AR-07-1162

Southern Nuclear Operating Company
Vogtle Early Site Permit Application
Supplemental Response to Requests for Additional Information on Geology/Seismology

Supplemental Response to Geology/Seismology RAIs

Vogtle ESP Application

Figure 1g. Quadratic fit to the amplification values for 0.5 Hz.

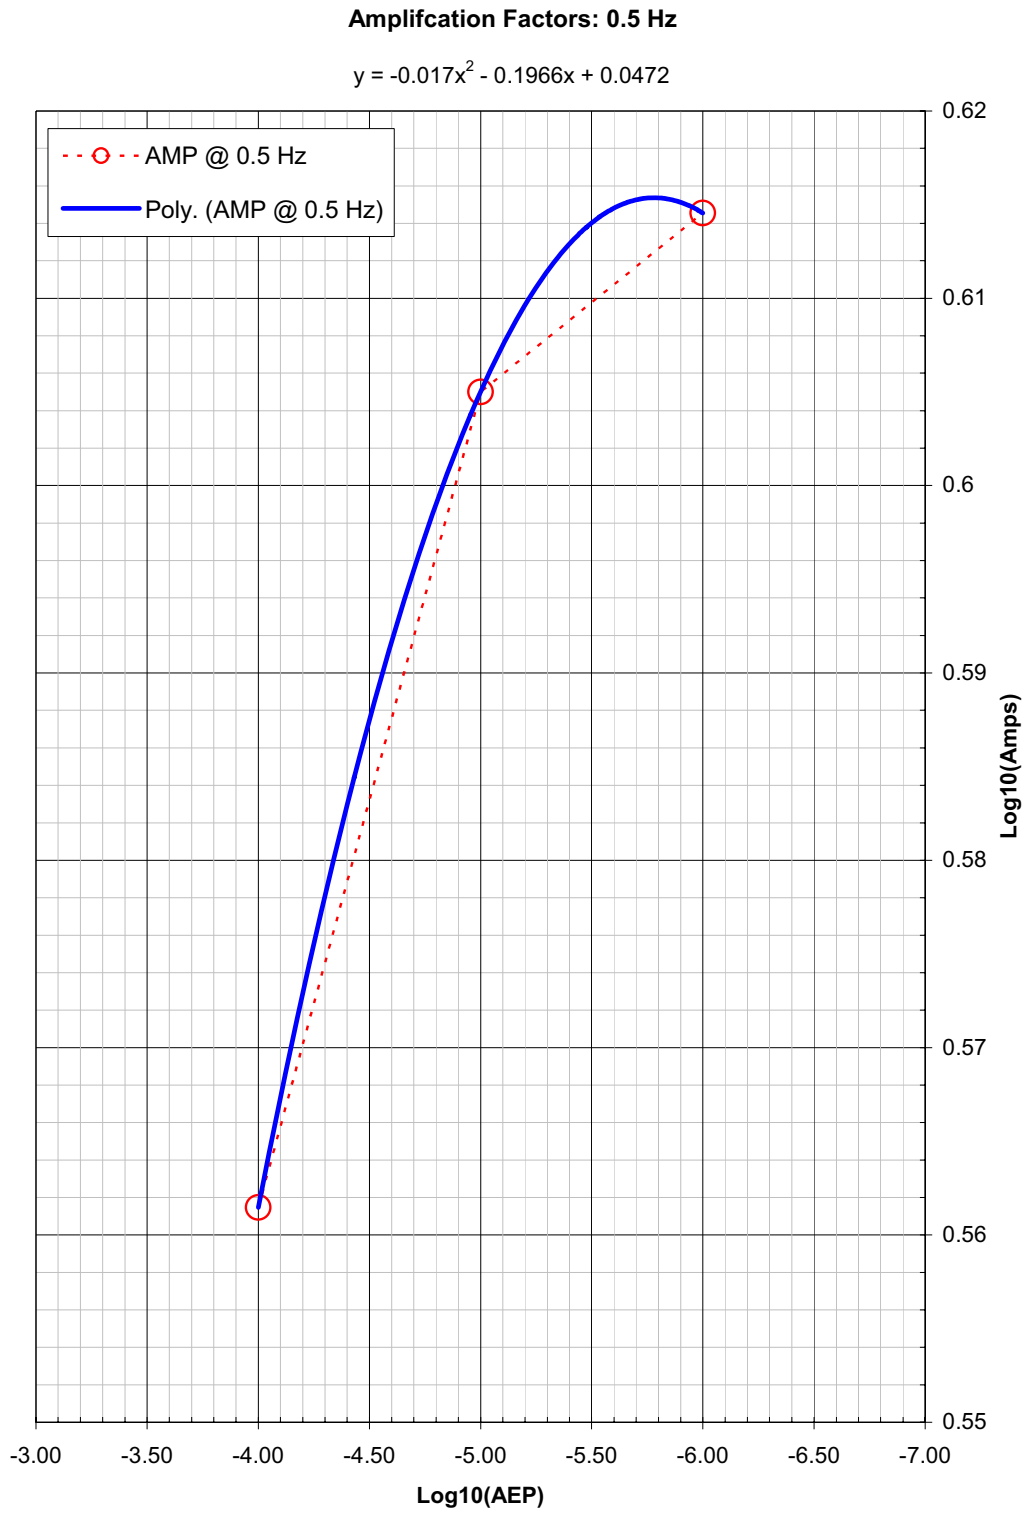
2.5.2-3 In response to this RAI, soil hazard curves were provided at three annual exceedence frequencies (10^{-4} , 10^{-5} , and 10^{-6}). However, in order for the staff to verify the adequacy of the SSE, soil hazard curves are requested at additional annual exceedence frequencies (i.e. at values between 10^{-4} , 10^{-5} , and 10^{-6}).

For each of the seven frequencies a quadratic equation was fit to the log (base10) of the spectral ratios (AMP) as a function of the log (base10) of the annual exceedence probability (AEP). Mathematically, this functional model is given as,

The resulting fits to the three data points are shown in Figure 1, located on the following pages, for each of the seven frequencies. The coefficients and equation are given at the top of each plot. Note that the red dashed line is a linear log-log line between the three data points.

Figure 2.5.2-18A: Seismicity in southeastern US and areas used to examine seismicity effects.

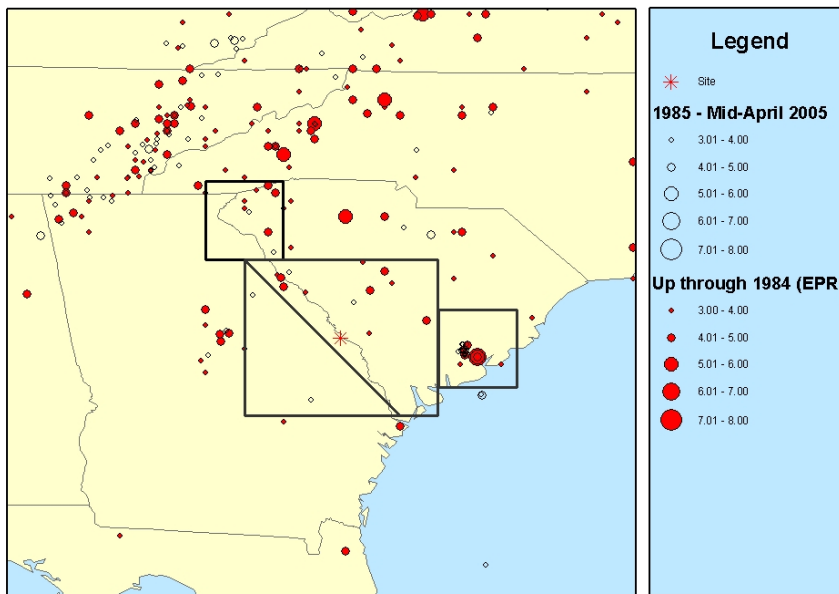
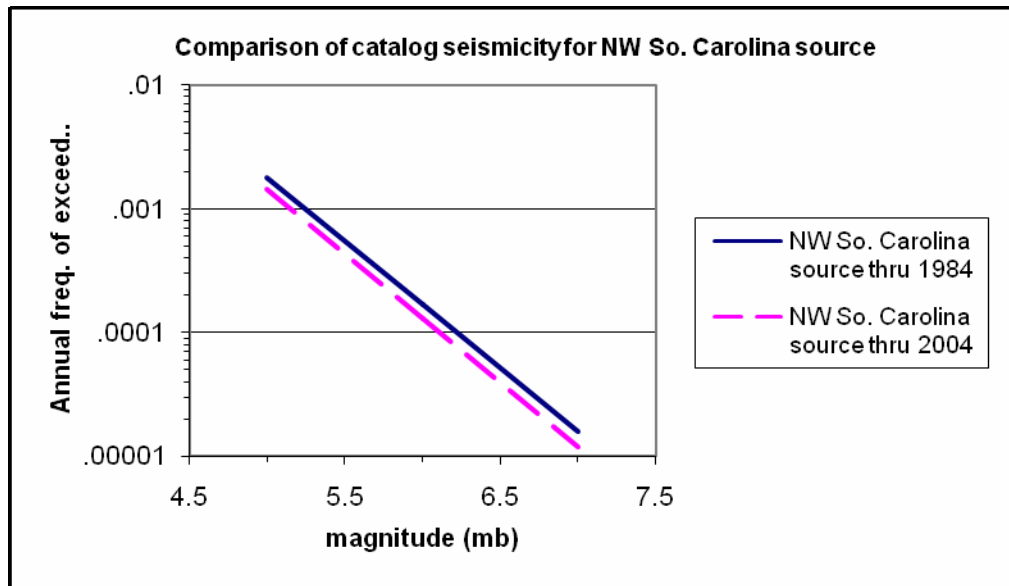
2.5.2-18 Please provide justification for the selection of the geometries shown in SSAR Figure 2.5.2-16 as well as RAI Figure 2.5.2-18A. Specifically, why were these particular geometries selected over other possible geometries? In addition, please justify the exclusion of the recent seismicity associated with the Helena Banks fault zone from all of the selected geometries.

Several areas were used to examine the effect of the new regional earthquake catalog. RAI figure 2.5.2-18A shows these areas. The areas were selected because sensitivity studies showed that seismic sources in the vicinity of the site, in the Charleston, South Carolina region, and in northwestern South Carolina were the main contributors to seismic hazard at the Vogtle site. The large rectangular source surrounding the site spans 2.5° longitude by 2° latitude, the source representing Charleston, South Carolina, spans 1° longitude by 1° latitude, and the source in northwestern South Carolina spans 1° longitude by 1° latitude. These sources were selected as representative of the regions important to seismic hazard analysis. In addition, the large source surrounding the site was divided with a diagonal line to capture seismicity in the northeast half of the source, so that seismicity would not be combined with the relatively aseismic, southwest half of the source.

All four regions showed the same result, that additional seismicity from 1985 to mid-2004 does not increase estimated activity rates in the area around the Vogtle site. As an example, RAI Figure 2.5.2-18B shows the effect of additional seismicity in the square, northwestern South Carolina source shown in RAI Figure 2.5.2-18A. The estimated activity rate decreases, similar to what is shown in SSAR Figure 2.5.2-18. We conclude that any region in South Carolina that would affect the seismic hazard of Vogtle would have estimated activity rates that stay constant or decrease, if the new regional earthquake catalog were added to the analysis.

The seismicity in the area of the Helena Banks fault zone was not considered separately because low-magnitude seismicity offshore would not contribute significantly to seismic hazard at the Vogtle site. As an example, the low-magnitude seismicity in the Charleston region is modeled in the seismic hazard calculations with an exponential magnitude distribution using the EPRI-SOG team interpretations of seismicity rates. The seismic hazard from this model is negligible compared to the seismic hazard from the large-magnitude, characteristic model of earthquakes in the Charleston region.

SSAR Figure 2.5.2-37 Typical Results of Spectral Amplification at 86-ft Depth (Top of Blue Bluff Marl) Using EPRI Degradation Curves for High Frequency Time Histories of 10^{-4} MAFE Input Motion Level

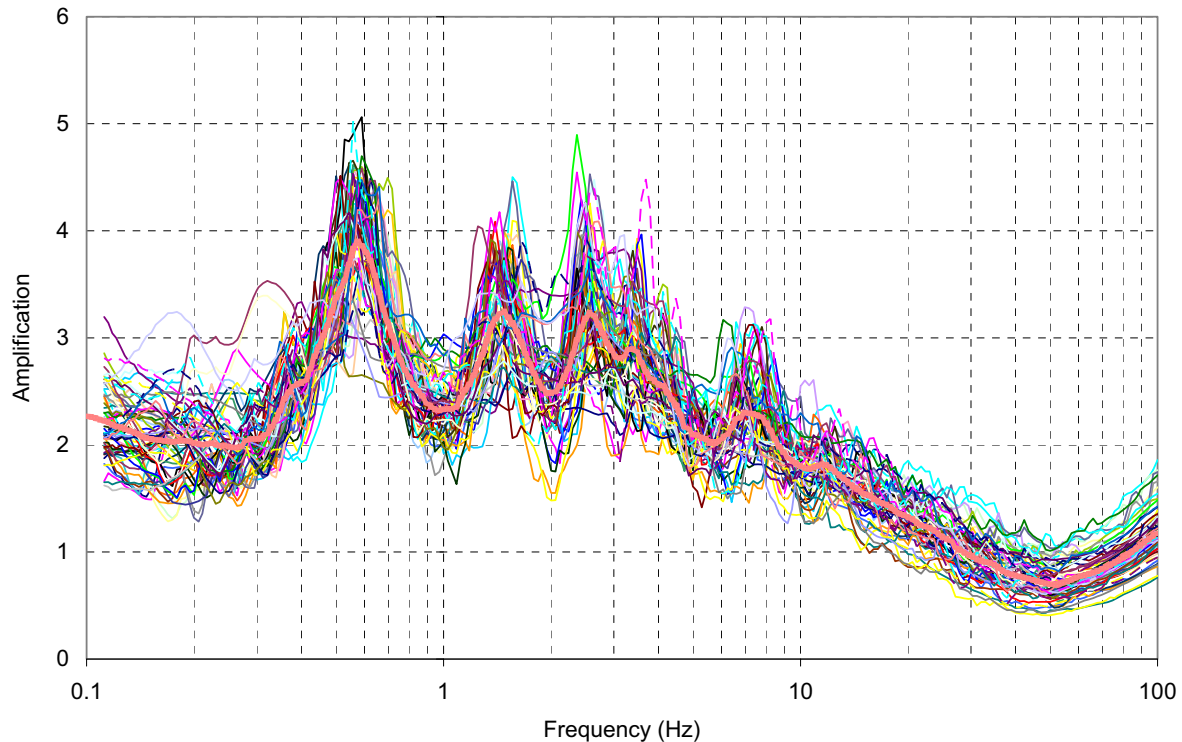
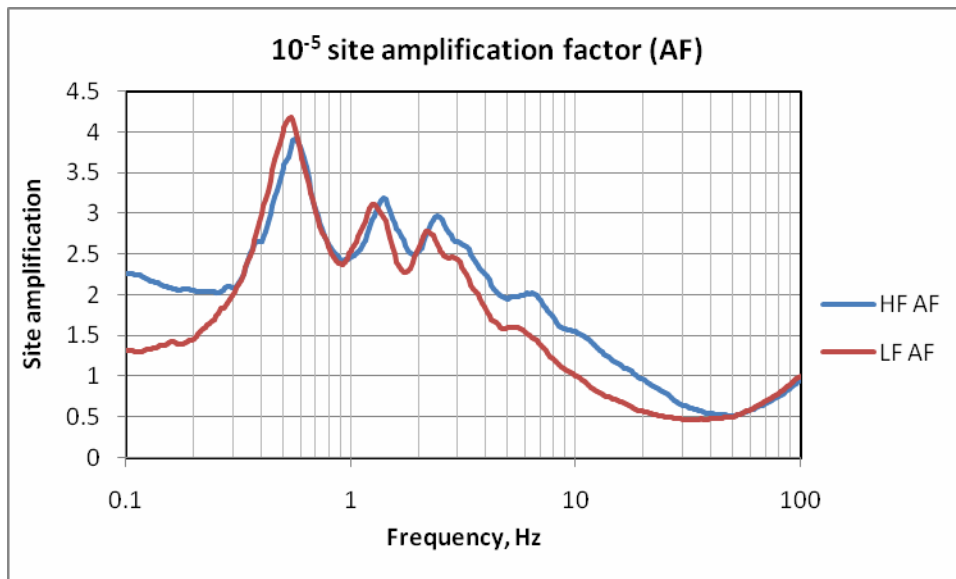
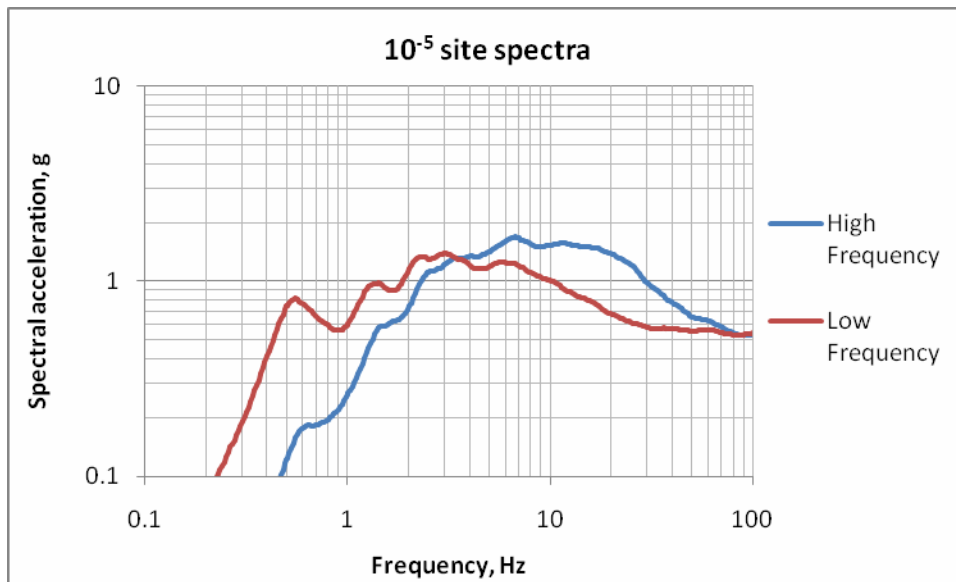
2.5.2-19 Supplement the RAI with additional information related to STEP 5. Please include a definition, and a figure (or table), of the envelope motion. The response to this RAI states

However, it is not clear if the envelope motion refers to the envelope of the mean AFs or envelope of the mean response spectra at the control point.

STEP 5A: The mean and standard deviation of amplification factors [AFs] (soil SA divided by rock SA at each of the 300 structural frequencies) is calculated using the 60 randomized sets of soil/rock characteristics. (Means and standard deviations are calculated logarithmically.) This results in 12 sets of mean AFs (one set being for the 300 structural frequencies), as follows:

SSAR Figure 2.5.2-37, repeated below, illustrates the 60 individual AFs and the logarithmic mean AF across the frequency range of 0.1 Hz to 100 Hz, for the 10^{-4} MAFE, HF input, EPRI mean material curves, and 86' depth.

STEP 5B: The mean AFs for the EPRI and SRS material curves are equally weighted, to give 6 mean AFs across the frequency range 0.1 Hz to 100 Hz, for the control point horizon. These 6 mean AFs correspond to the 3 ground motion levels and to the HF and LF input motions.

STEP 5C: The controlling HF or LF input motion is determined over the frequency range 0.1 Hz to 100 Hz for each MAFE, by examining the envelope of soil response spectra at the control point location (86' depth) due to the HF and LF rock motion. Figure 2.5.2-Y1 gives an example of logarithmic mean amplification factor as a function of frequency for the control point location for the HF and LF 10^{-5} motion. Figure 2.5.2-Y2 gives an example of the resulting 10^{-5} site response spectra calculated by multiplying the 10^{-5} input rock motion by the logarithmic mean AF values from Figure 2.5.2-Y1. Note from Figure 2.4.2-Y1 that at very low frequencies the HF amplification factor exceeds the LF amplification factor, because the HF input rock motion does not include much low-frequency content (the denominator of the ratio of site response divided by rock input motion is low). Figure 2.5.2-Y2 shows that, at high frequencies, the HF site response spectrum equals or exceeds the LF site response spectrum and at low frequencies, the reverse is true. This means that the HF input rock motion will control the high frequencies (above 8 Hz) soil responses and the LF input rock motion will control the low frequencies soil responses (below 2 Hz). In between, the controlling motion, which is the maximum soil response, depends on the MAFE and the frequency. This step results in one set of mean AFs (across the frequency range 0.1 Hz to 100 Hz) for each MAFE.
